Initial burst pressure requirement for the hydrogen storage containers

Transmitted by Japan

3rd Meeting of the informal working group on GTR No.13 (Phase 2)
26-28 June 2018 @ Seoul, Korea

Figure x Relationship between the initial BP and end-of-life BP (Estimation)

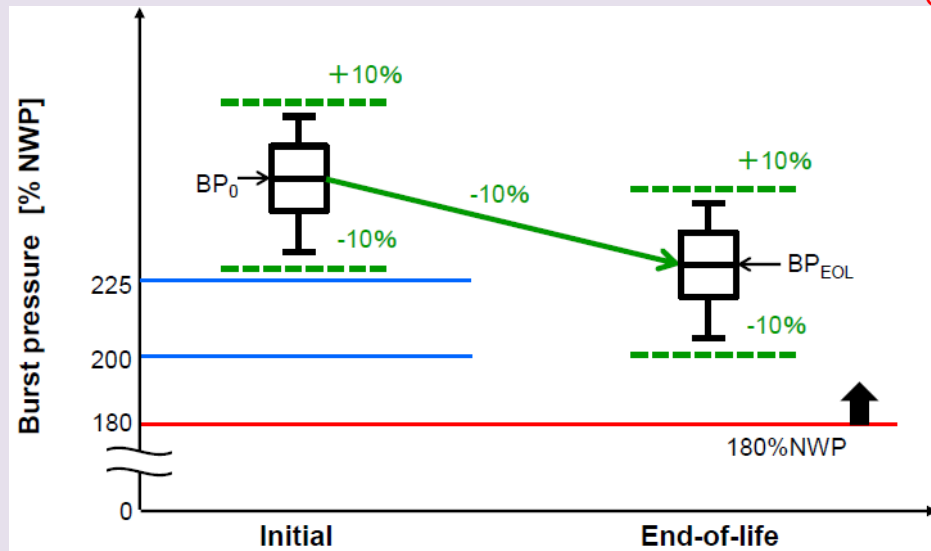
Validate the minimum initial burst pressure with the variation within $BP_0 \pm 10\%$ to secure the end-of-life burst pressure 180% NWP and to be within -20% of BP_0 . See the estimation of figure x.

In the subsequent discussions of the phase 2, it has been verified that the minimum initial burst pressure shall be changed from 225% NWP to 200% NWP limited to carbon fiber containers ,based on the verification data provided from Japan using the actual containers.

Figure xx The results from the verification test

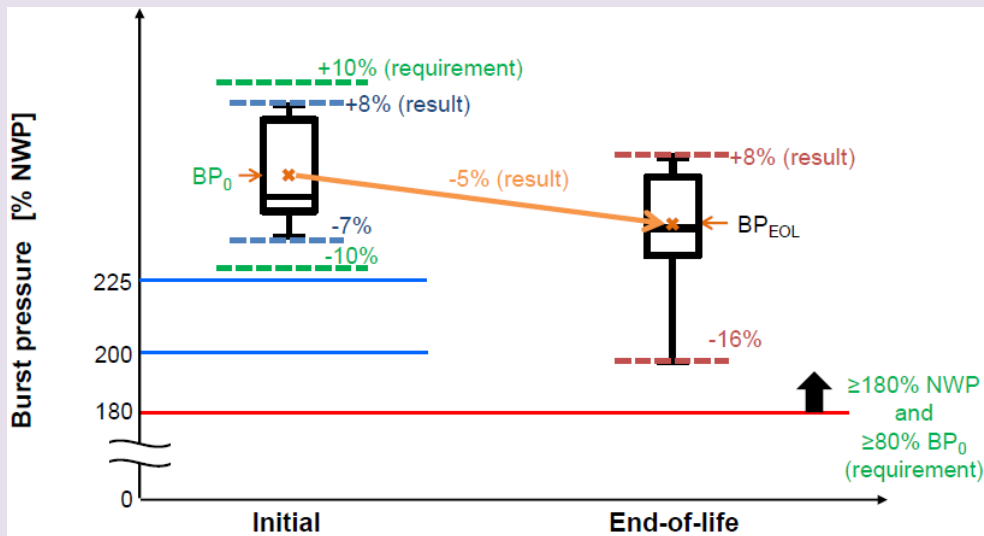
From figure xx, found out the variation of initial burst pressure of $BP_0 \leq \pm 10\%$, and the margin of end-of-life burst pressure to the requirements taking into account the variation and the degradation ratio. As the results like figure xxx, it has been validated that the minimum initial burst pressure of 200% NWP ($BP_0 \geq 220\%$ NWP), the end-of-life burst pressure of 180% NWP and to be within -20% of BP_0 shall be specified.

The investigation of the burst pressure degradation

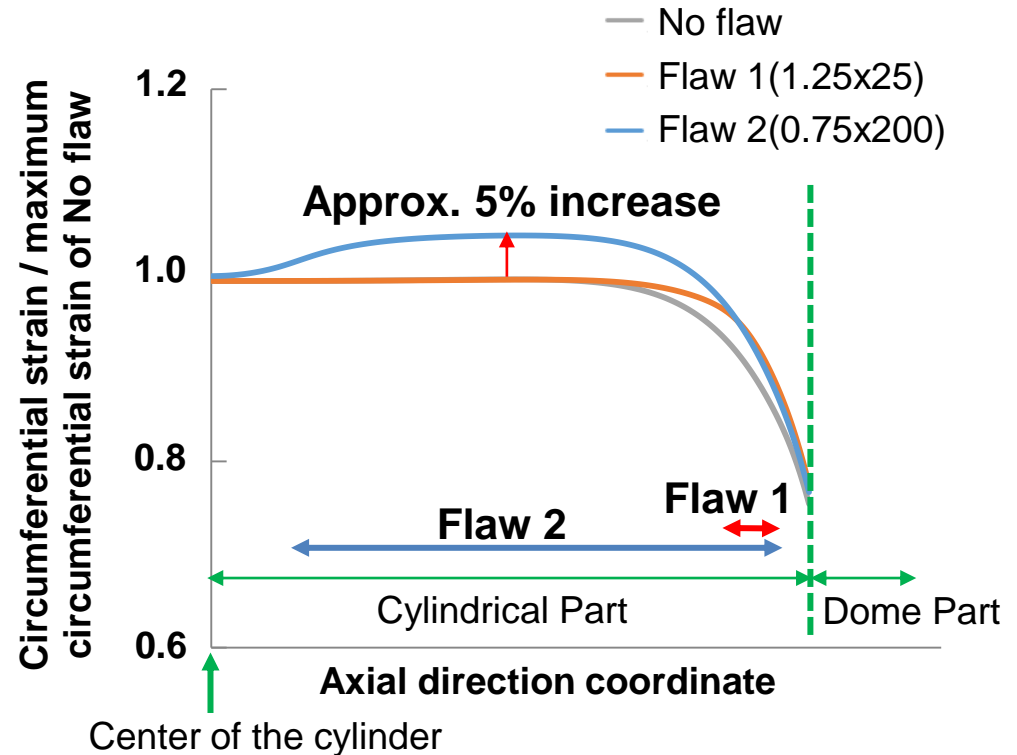
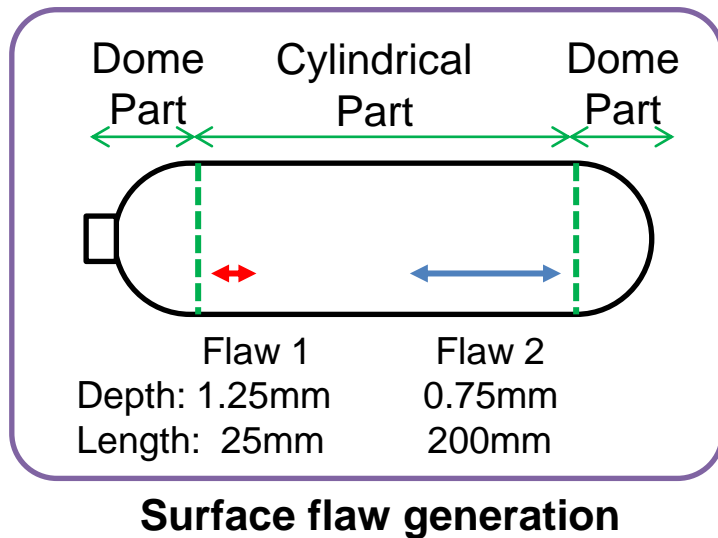
- In the case of the rupture from **the cylindrical part**
 - The influence investigation of the surface flaw by finite element analysis

- The circumferential strain of CFRP in cylindrical part increased approx.5% due to surface flaw.
 - **The surface flaw is considered to be the factor of the decrease in burst pressure as the starting point of rupture in cylindrical part.**

The investigation of the burst pressure degradation

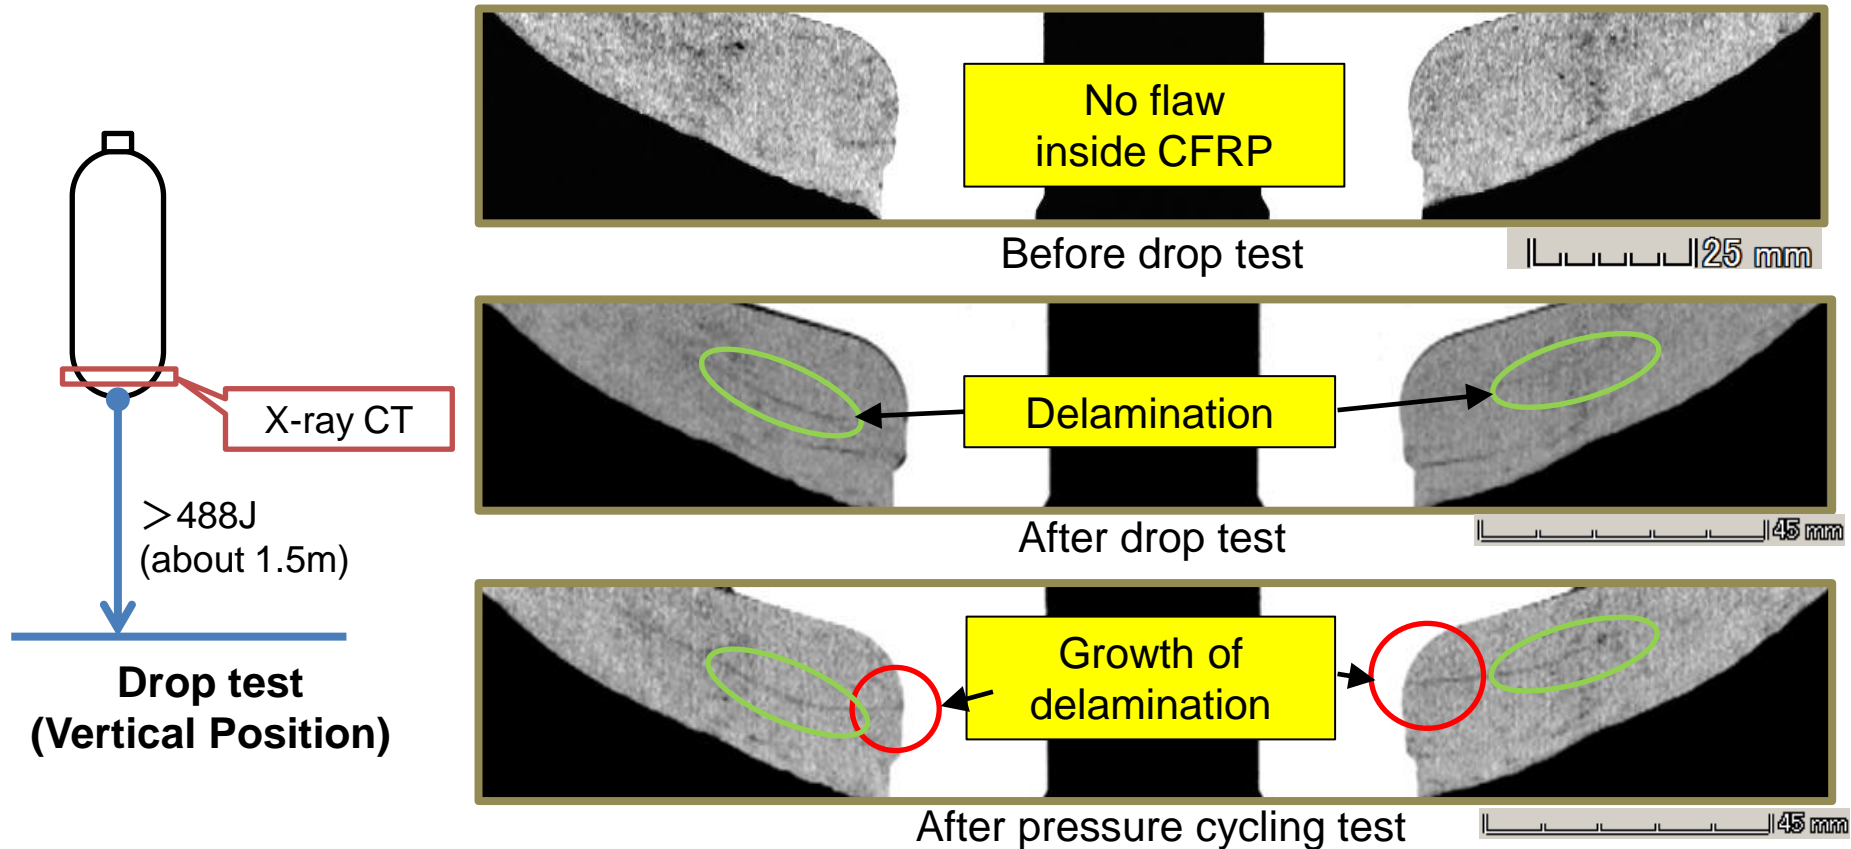
- The influence investigation of the drop flaw by X-ray CT scanning

- Damage progress in CFRP by the drop test.

No flaw (initial) ➤ Delamination (after drop) ➤ Growth of delamination (after cycling)

- **The delamination inside CFRP by the drop test is considered to be the factor of the decrease in burst pressure as the starting point of rupture in dome part.**

The study from the results of the verification test

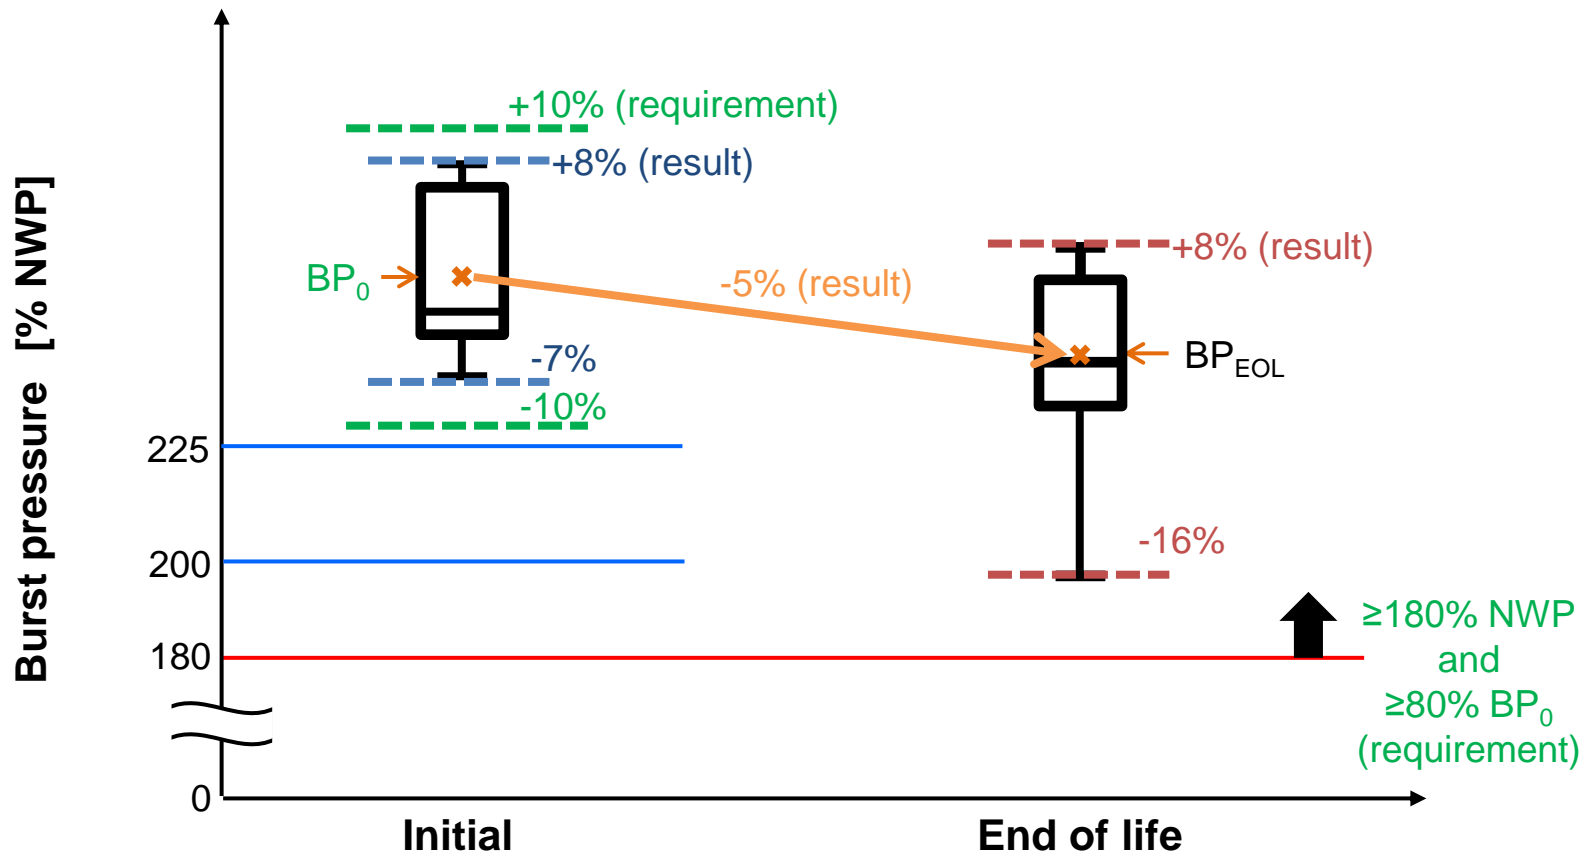
- Initial burst pressure : +8% / -7% of BP_0 → meet the requirement ($\pm 10\%$ of BP_0)
- EOL burst pressure : +8% / -16% of BP_{EOL} → meet the requirement
($\geq 180\%$ NWP and $\geq 80\%$ BP_0)
- **200% NWP as the initial burst pressure (BP_{min}) can be correlated with EOL burst pressure (for CFRP cylinders)**

The possibility of the design qualification test modification

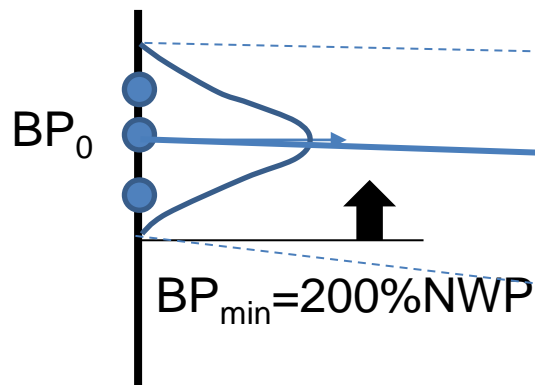
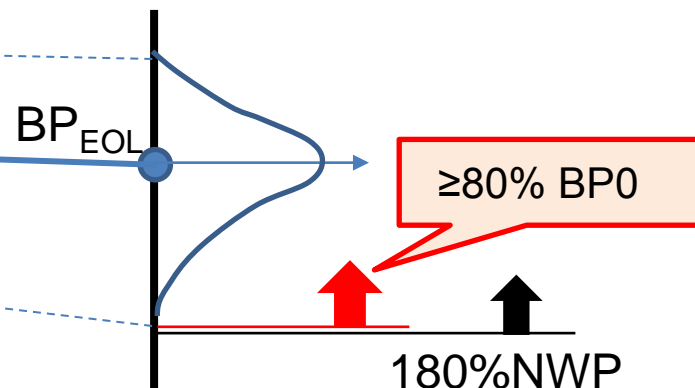
- Change from 225% NWP to 200% NWP as the minimum initial burst pressure BP_{min}
- No change of the design qualification test without the requirement of BP_{min} (above)

Three (3) new containers randomly selected from the design qualification batch of at least 10 containers, are hydraulically pressurized until burst. All containers tested shall have a burst pressure within ± 10 per cent of BP_0 and greater than or equal to a minimum BP_{min} of **200 ~~225~~ per cent NWP**.
